# DENVER AMENDMENT PROPOSAL FORM FOR PROPOSALS TO THE 2019 DENVER BUILDING CODE AMENDMENTS AND THE 2021 INTERNATIONAL CODES

## 2021 CODE DEVELOPMENT CYCLE

**IBC 713.13.1 Waste, recycling and linen chute enclosures**

Commentary Figure 713.13.3  
REFUSE CHUTE (FIRE BARRIER OPTION)

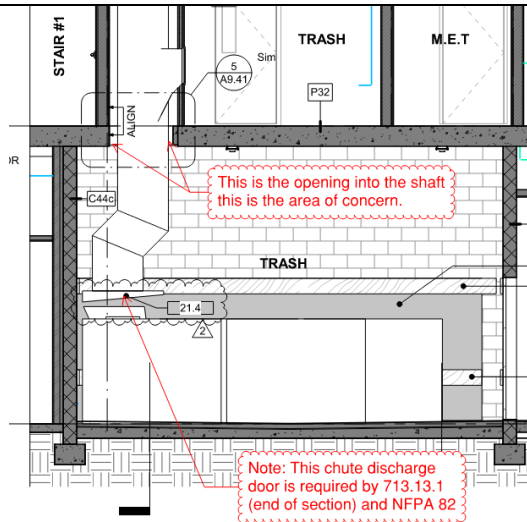
**Supporting Information (Required):** The problem with this code section comes in at the highlighted section in the code language below. Also included is a picture from the IBC Code Commentary to show the location that we see the most issues with. Typically, we have been allowing mineral wool packed around the chute to fill the annular space instead of strict compliance with 716, which is difficult and impractical to achieve where the chute extends through the bottom enclosure to the place of discharge. In 716 it is unclear how to protect that opening when you have the chute coming through it. Something has to protect that annular space, we understand that. But the code language in 716 just doesn't tell us what we should absolutely require.

We feel that this method of filling the annular space with mineral wool or other approved materials meets the intent of the code and should be made an exception since it is what we are already allowing. Note that the discharge door of the chute in this condition would still be required to have an automatic closing or self-closing fire rated door per NFPA 82, Chapter 6, which is referenced in IBC 713.13 - IBC 713.13.1 has similar requirements. Also, waste and linen shafts must discharge into a room with a fire-resistance rating not less than required for the shaft (IBC 713.13.4), which is typically allowed as a means to protect the bottom of a shaft enclosure (IBC 713.11 Item 2).

**4 E/W TRASH CHUTE SECTION**  
 A7.31 SCALE: 1/4" = 1'-0"

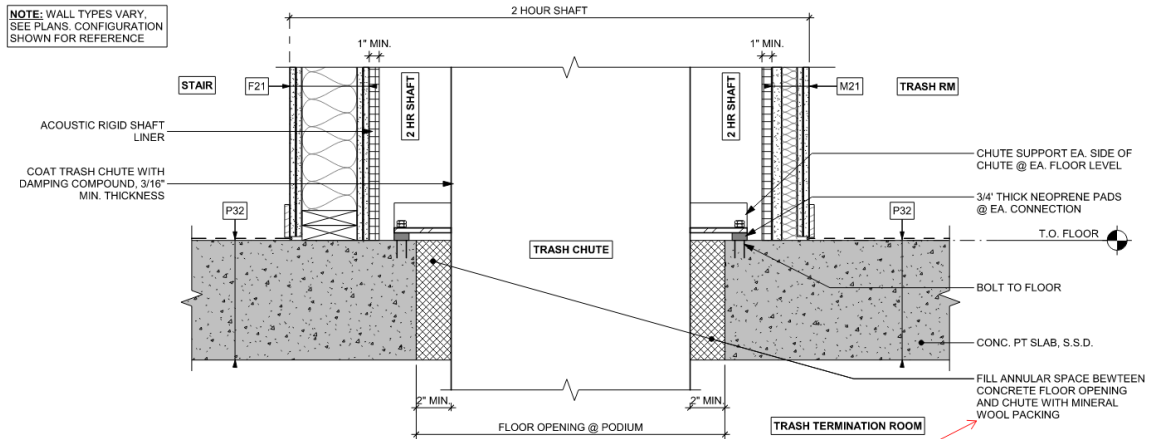
Here are some common details that we see on plans:

This is what we are proposing / allowing
